# UNITED STATES PATENT AND TRADEMARK OFFICE

APPLICATION NO.	FILING DATE	FIRST NAMED INVENTOR	ATTORNEY DOCKET NO.	CONFIRMATION NO.
10/622,960	07/18/2003	Ralph D. Geater	GEAT100USA	4002
24339	7590	05/12/2004	EXAMINER	
JOEL D. SKINNER, JR. SKINNER AND ASSOCIATES 212 COMMERCIAL ST. HUDSON, WI 54016			SZUMNY, JONATHON A	
			ART UNIT	PAPER NUMBER
			3632

This is the first office action for application number 10/622,960, Fastener Technology, filed on July 18, 2003.

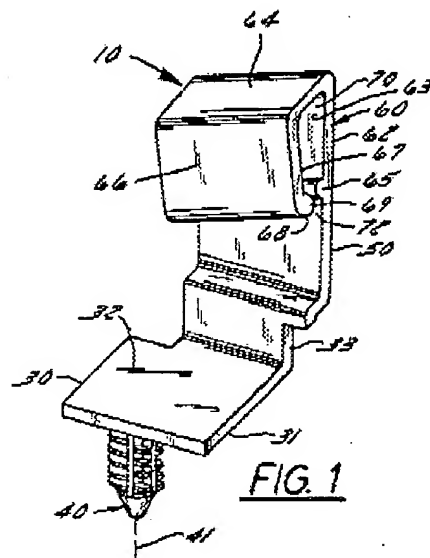
Claims 1-6, 9-12 and 16-18 are rejected under 35 U.S.C. 102(b) as being anticipated by U.S. Patent number 4,865,281 to Wollar.

Wollar '281 discloses a unitary/plastic device (above, column 3, lines 45-46) comprising a rectilinear frame (50,33 generally), a leg (30) communicatively connected to the frame, and an curvilinear arm (64,66, it is curvilinear at where "10" is pointed in figure 3) connected to the frame and defining a passage (70) in which an article (14) is disposed; wherein the frame has first and second ends (near 33 and near 64, respectively) and a predetermined length, wherein the leg has a predetermined configuration with a predetermined area and depends from the first end of the frame at a right angle thereto, wherein the device includes connecting means (40), wherein the device could inherently attach to a wall stud, wherein the arm depends from the second end, wherein the arm is flexible (see column 3, lines 45-46), wherein can inherently be separated a predetermined distance from an external base object (see figure 3), wherein the article is an electrical cable (14, column 3, lines 29-30, "insulated flexible electric wires").

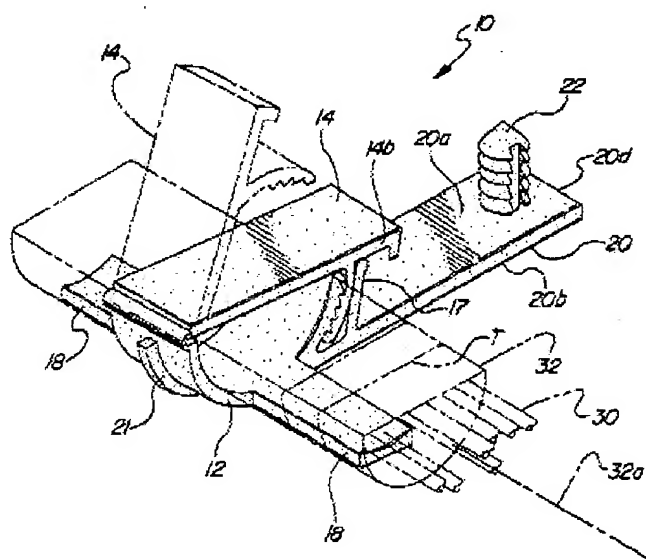
Claims 1-5, 10-12, 14, 15 and 19 are rejected under 35 U.S.C. 102(b) as being anticipated by U.S. Patent number 6,206,331 to Keith et al.

Keith et al. '331 discloses a unitary/plastic device (above) comprising a rectilinear frame (12,20), a leg (22) communicatively connected to the frame, and a flexible curvilinear arm (14,16, it is curvilinear at 16, it is flexible at 14a) connected to the frame and defining a passage (within 14,16) in which an article (30) is disposed; wherein the frame has first and second ends (near 20d and near where "21" is pointed in figure 2, respectively) and a predetermined length, wherein the leg has a predetermined configuration with a predetermined area and depends from the first end of the frame at a right angle thereto, wherein the arm depends from the second end, wherein a lock

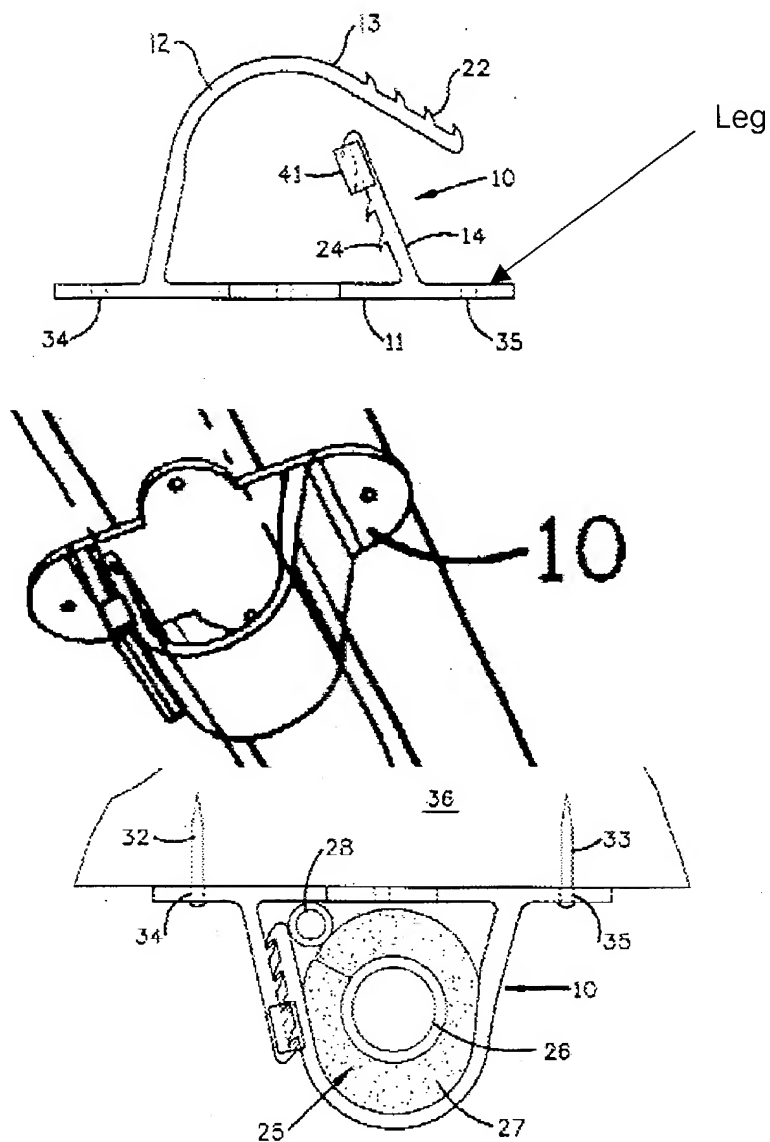
member (12a) is connected to the frame, wherein the arm has a locking end (16a) which releasably mates (see column 2, lines 60-64) with the lock member, wherein the lock member and locking end have complementary mating notches (between teeth), wherein the arm also has a rectilinear configuration (top of 14) defines a substantially cylindrical passage (inside of 16) with open ends, wherein the arm has a free end (tip of 16) couplable to the lock member.
